# **Lower Thames Crossing**

## **Thurrock Council's Comments on Selected Applicant's Submissions at Deadline 4 (D4) and Localised Traffic Modelling Key Issues**

**03 October 2023**

**Thurrock Council**

**Plate 1: Total Junction Traffic Flow Comparison – 07:00 to 08:00**

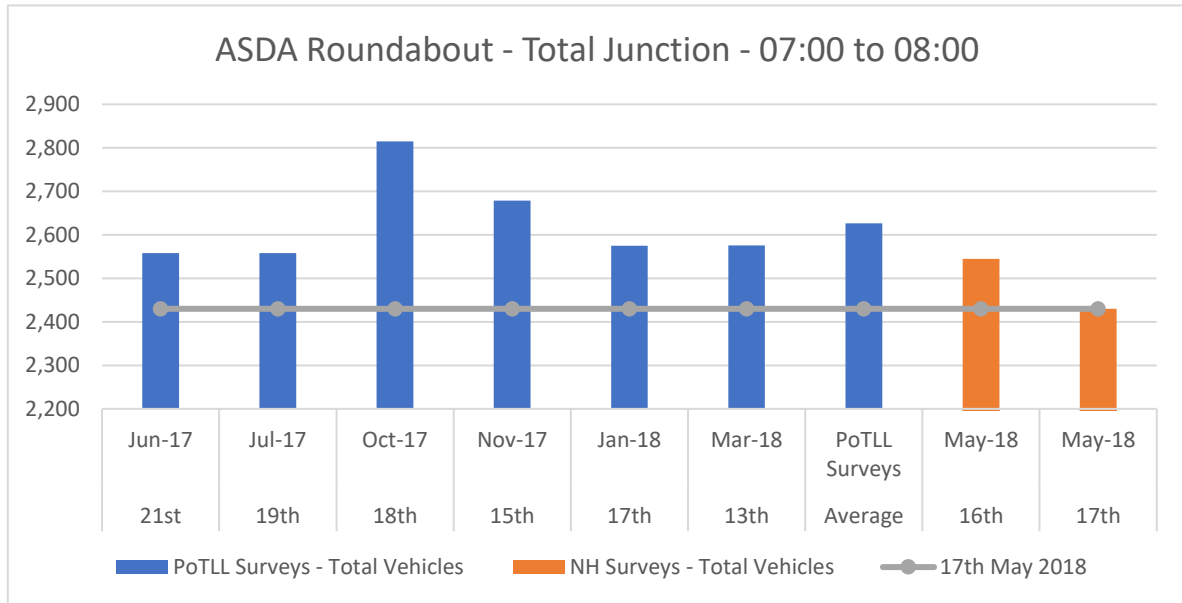
1.1.6 **Plate 1** details the total junction traffic flow comparison between the PoTLL surveys and the NH surveys, during the 07:00 to 08:00 AM peak hour. The average of the PoTLL surveys data is also shown for reference.

1.1.7 The 17 May 2018 data is the lowest of all count data. And the lowest of NH count data.

**Plate 2: A1089 St Andrews Road Traffic Flow Comparison – 07:00 to 08:00**

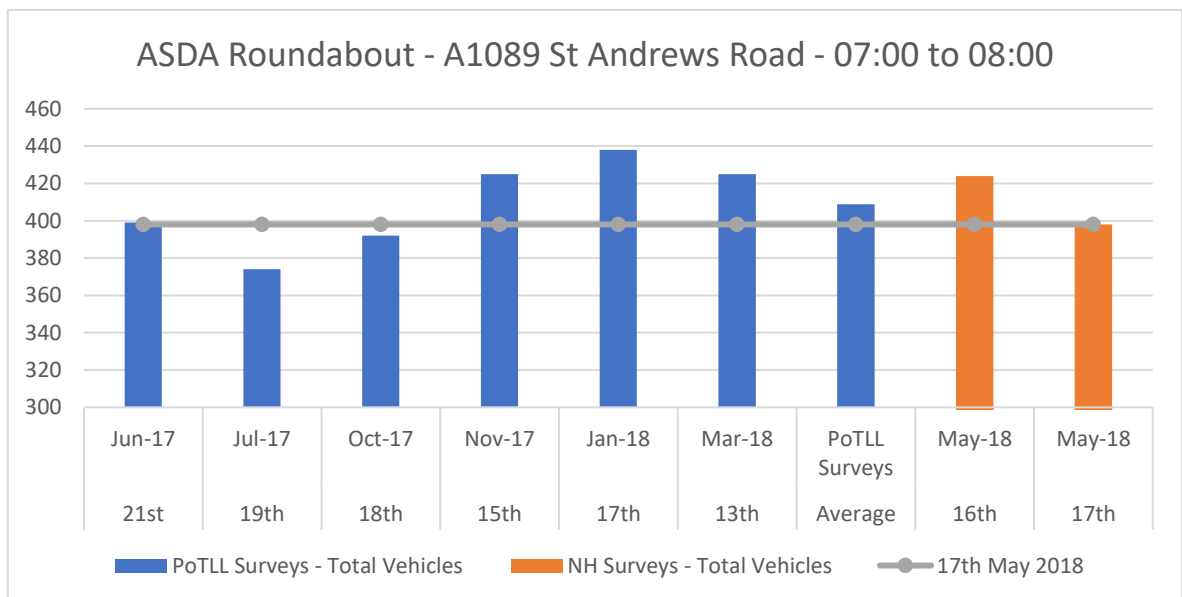
1.1.8 **Plate 2** details the A1089 St Andrews Road arm traffic flow comparison. Traffic flows are comparable.

**Plate 3: A1089 Dock Road Traffic Flow Comparison – 07:00 to 08:00**

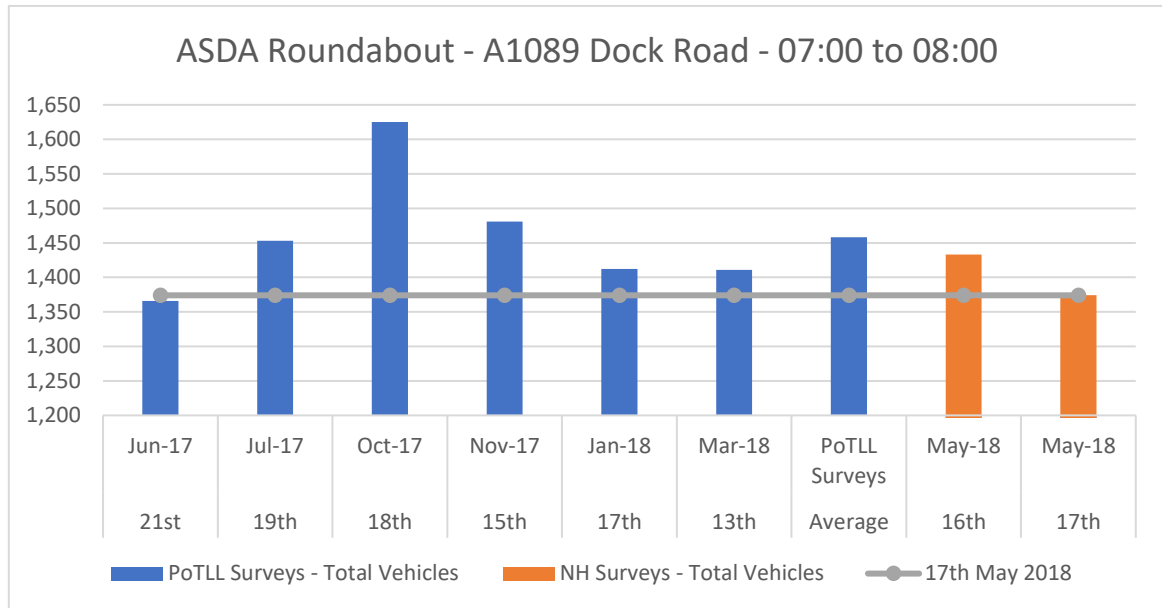
1.1.1 **Plate 3** details the A1089 Dock Road arm traffic flow comparison. The traffic flows on 17 May 2018 are equal lowest and below 16 May 2018.

**Plate 4: Total Junction Traffic Flow Comparison – 08:00 to 09:00**

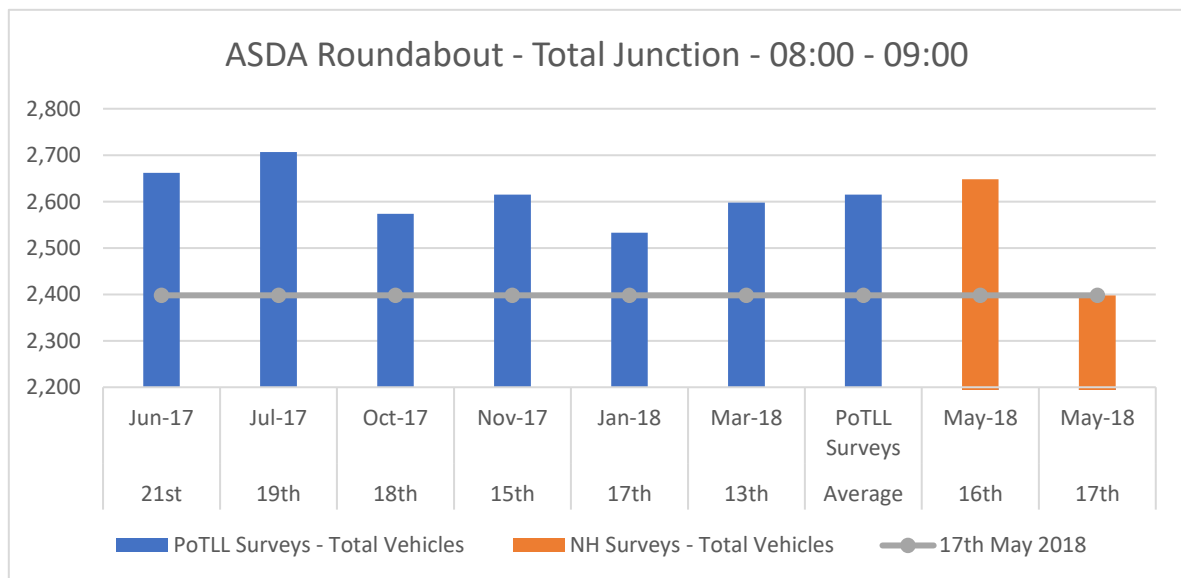
1.1.2 **Plate 4** details the total junction traffic flow comparison during the 08:00 to 09:00 AM peak hour.

1.1.3 The comparison highlights 17 May 2018 represents the lowest count data by a considerable margin. Generally, it is at least 10% lower.

**Plate 5: A1089 St Andrews Road Traffic Flow Comparison – 08:00 to 09:00**

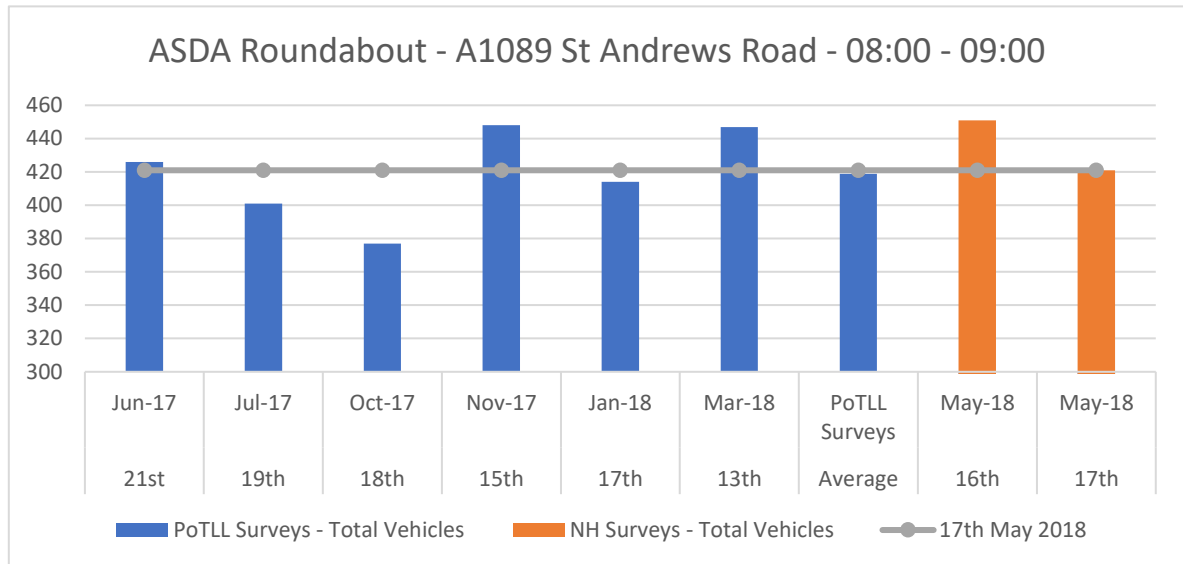
1.1.4 **Plate 5** details the A1089 St Andrews Road arm traffic flow comparison. There is little difference across the count data.

**Plate 6: A1089 Dock Road Traffic Flow Comparison – 08:00 to 09:00**

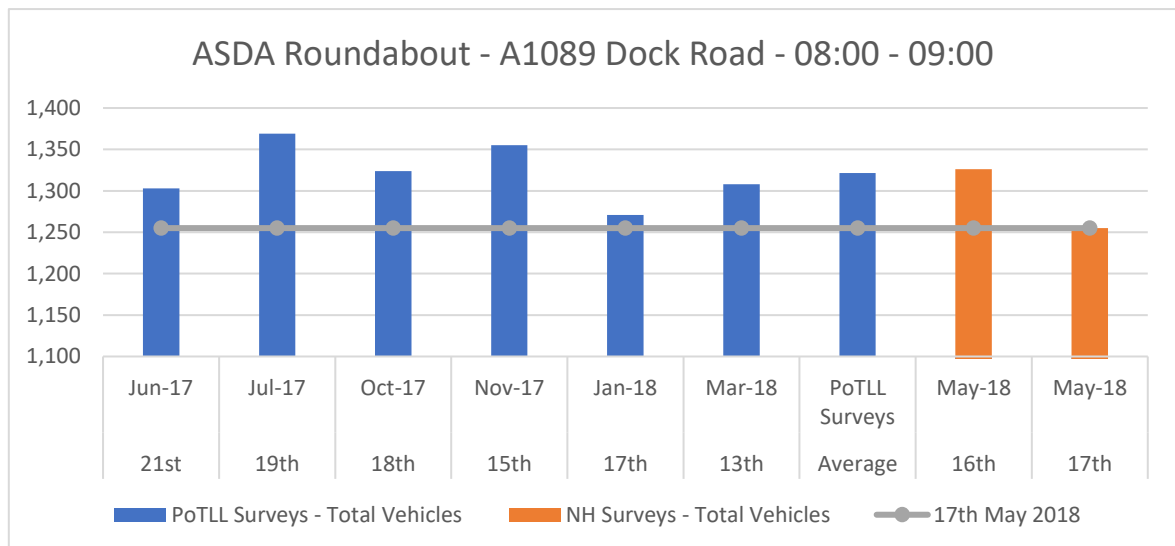
1.1.5 **Plate 6** details the A1089 Dock Road arm traffic flow comparison during the 08:00 to 09:00 AM peak hour. Again, there is a notable difference with the 17 May 2018 count data generally 10% lower than others.

**Plate 7: Total Junction Traffic Flow Comparison – 17:00 to 18:00**

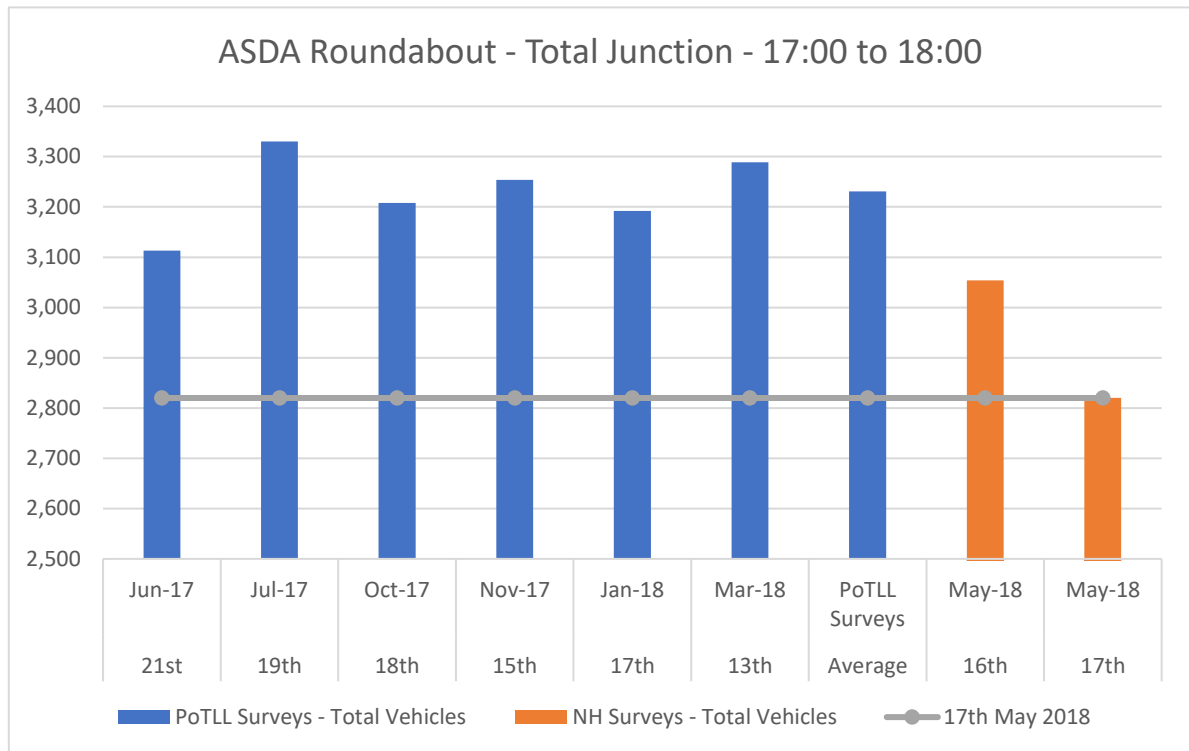
1.1.6 **Plate 4** details the total junction traffic flow comparison during the 17:00 to 18:00 PM peak hour. Again, the 17 May 2018 represents the lowest count data. It is between 10% and 20% lower than all the others.

**Plate 8: A1089 St Andrews Road Traffic Flow Comparison – 17:00 to 18:00**

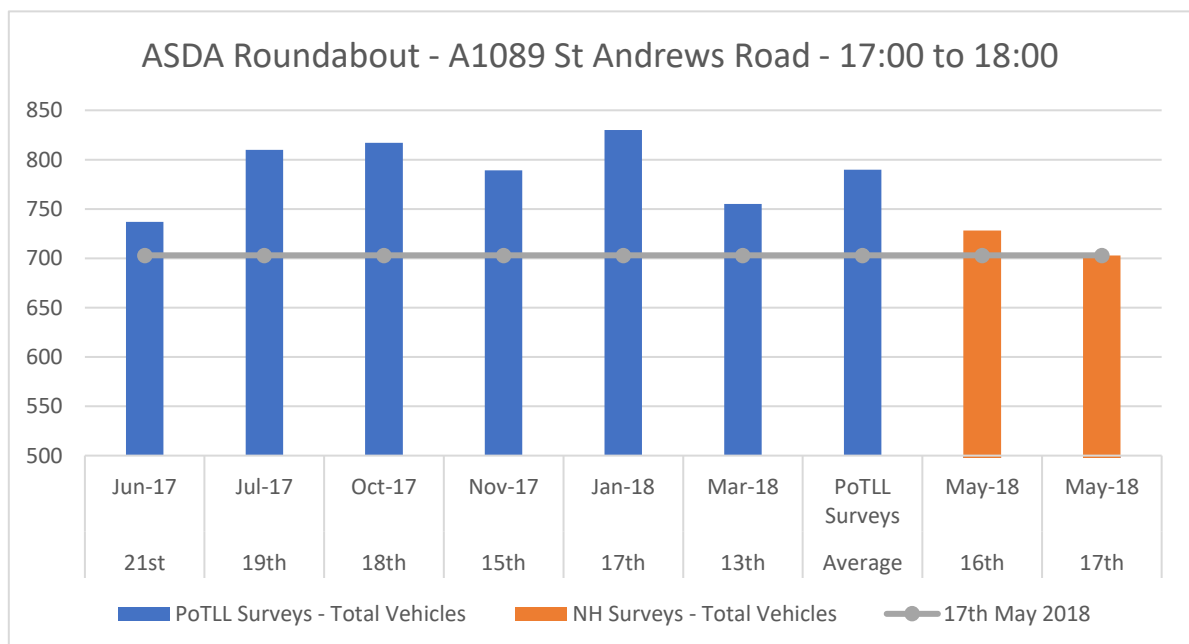
1.1.7 **Plate 8** details the A1089 St Andrews Road arm traffic flow comparison during the 17:00 to 18:00 PM peak hour. The 17 May 2018 count data is generally around 10% lower than all other data.
